Twickenham Riverside

DATE:	17 December 2021	CONFIDENTIALITY:	Confidential
SUBJECT:	LBRUT Transport Comments Review - WSP Response		
PROJECT:	Twickenham Riverside	AUTHOR:	Tim Gabbitas / Tom Edwards
CHECKED:	Tim Gabbitas	APPROVED:	DRAFT

[1] OVERVIEW

This document has been produced by WSP in response to the London Borough of Richmond upon Thames (LBRUT) document “*Twickenham Riverside – highways comments feedback to applicants (November 2021)*”.

DRAWING NO: TRS-WSP-SW-XX-DR-CV-SK0011	REV: P01
---	-----------------

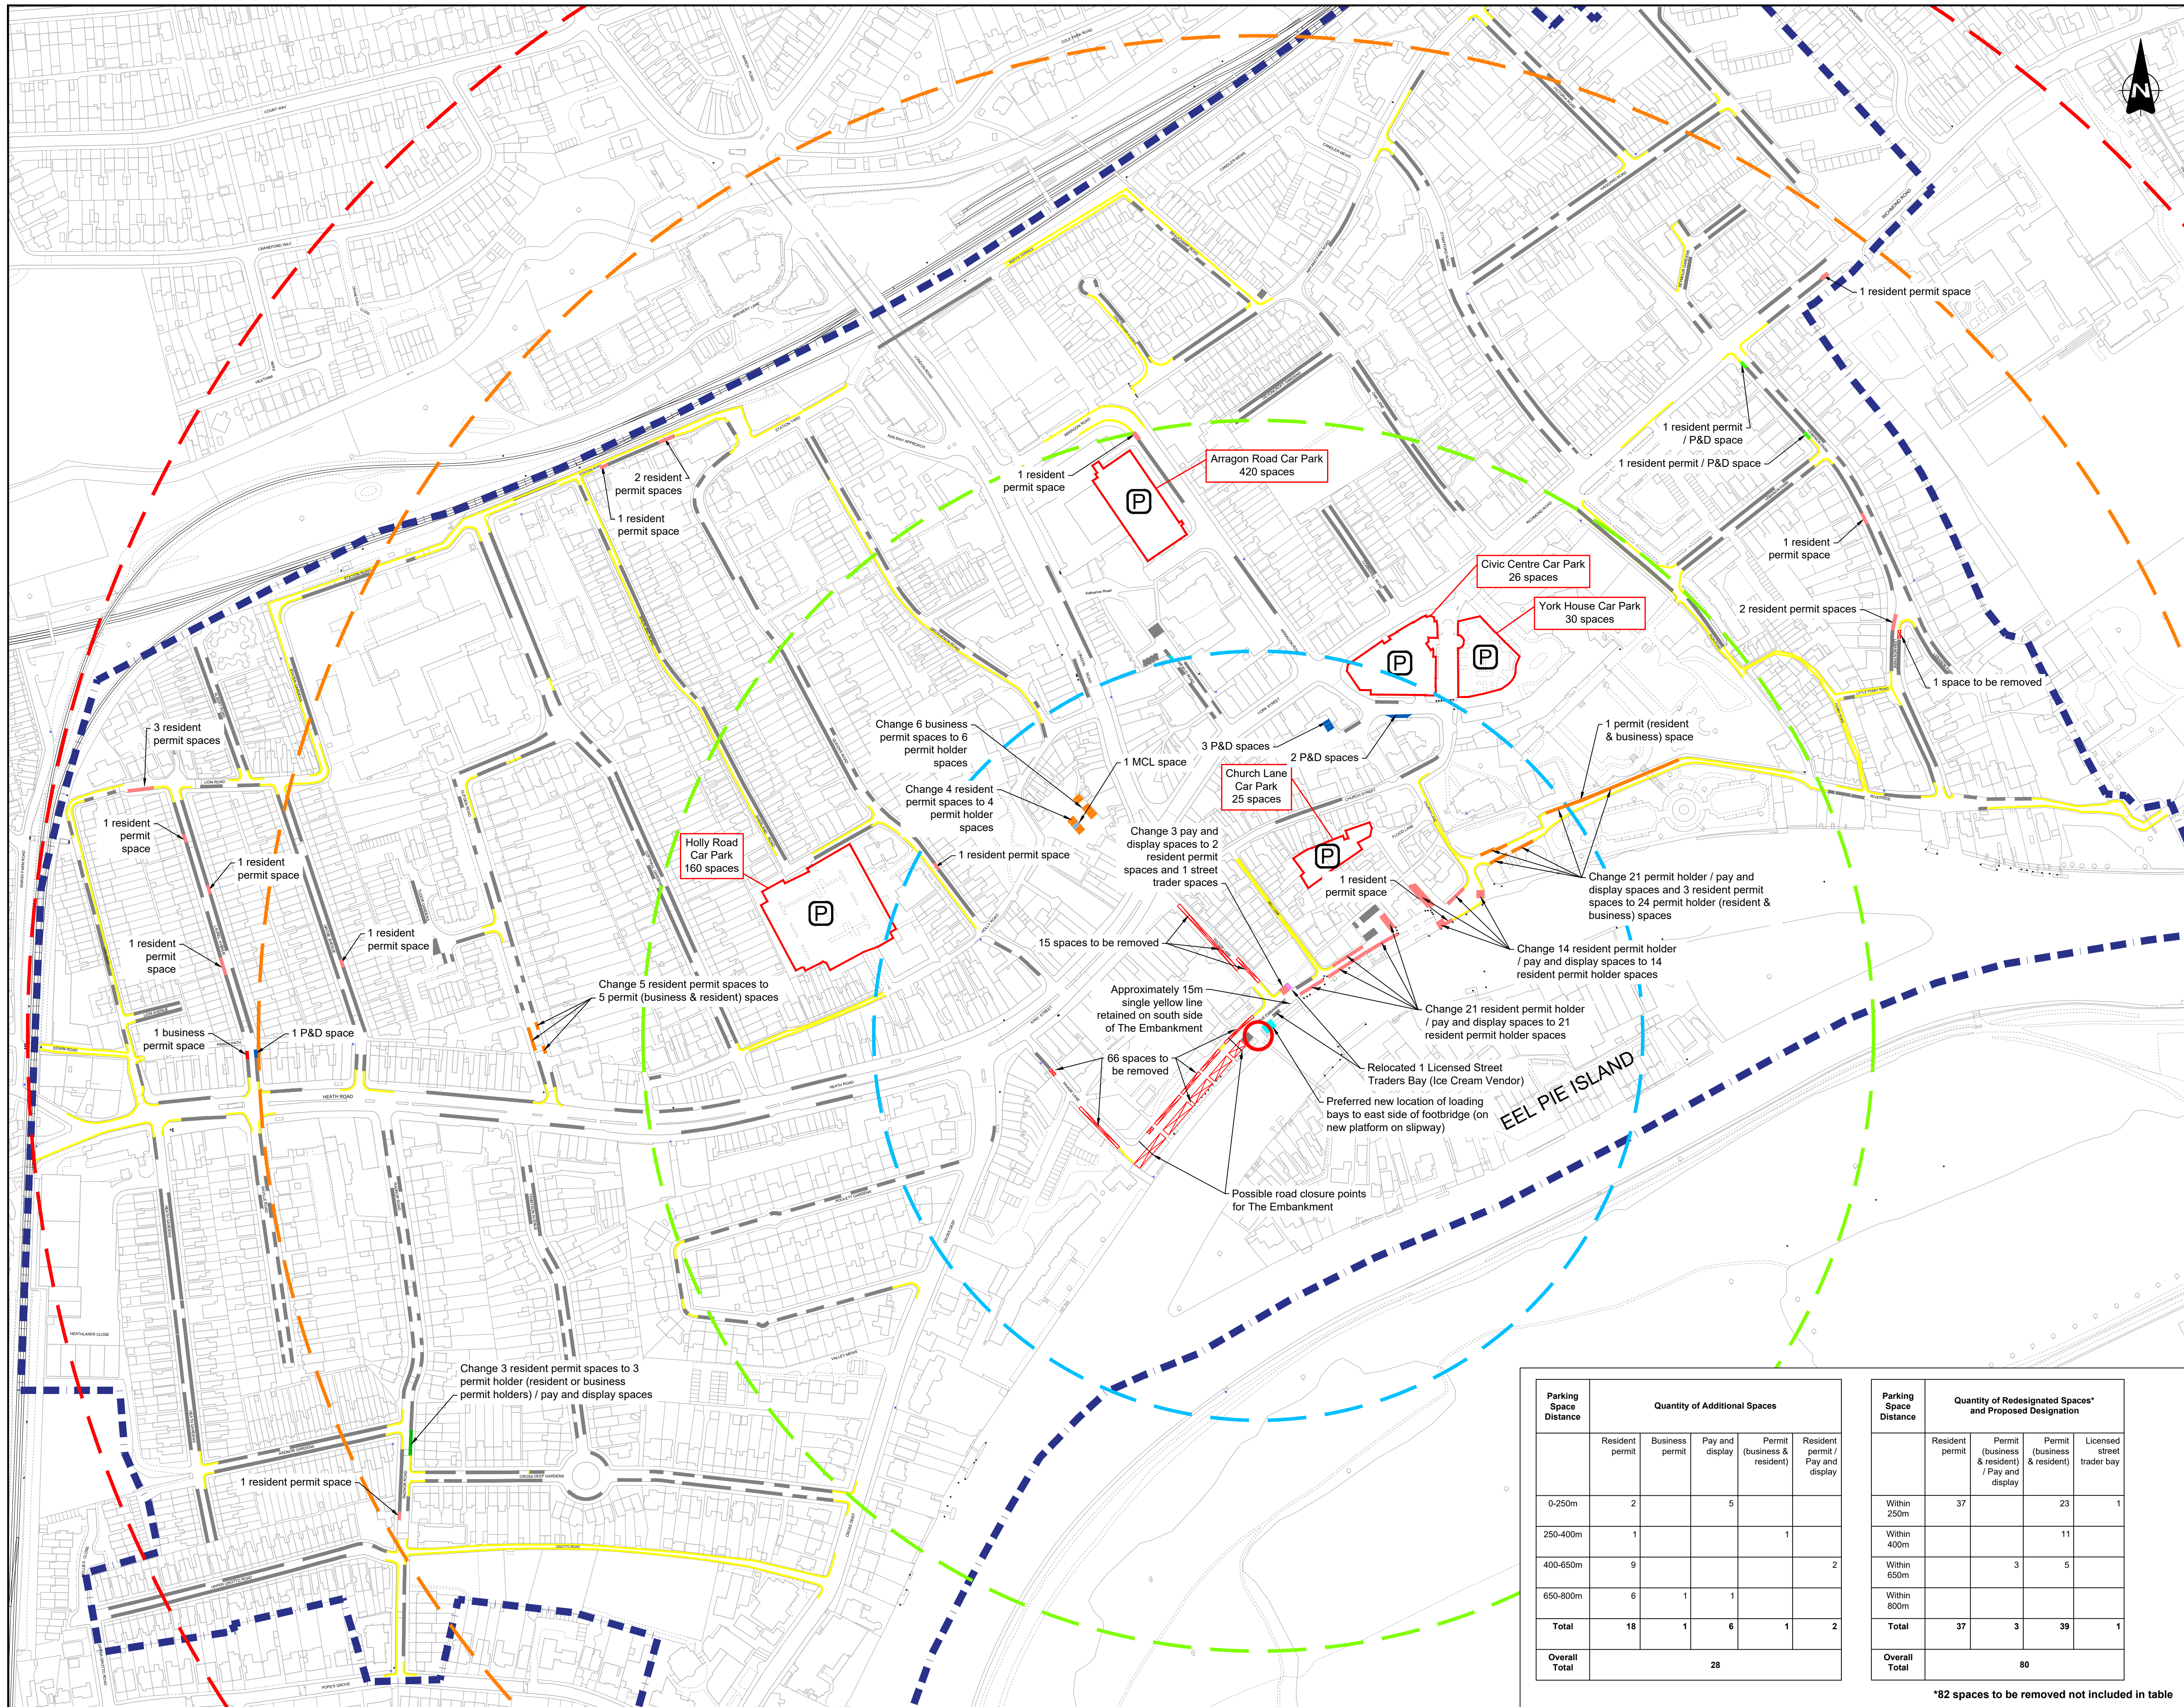
- b) A plan is required for the proposed highway and public realm works, showing the existing highway boundary to allow officers ascertain what areas need to be adopted, what works will take place on existing highway, and the existing highway that requires stopping up to enable the development to be built.

- This plan is in the process of being finalised with the design team through Stage 4 and has been included within the drawing packages associated with this document.
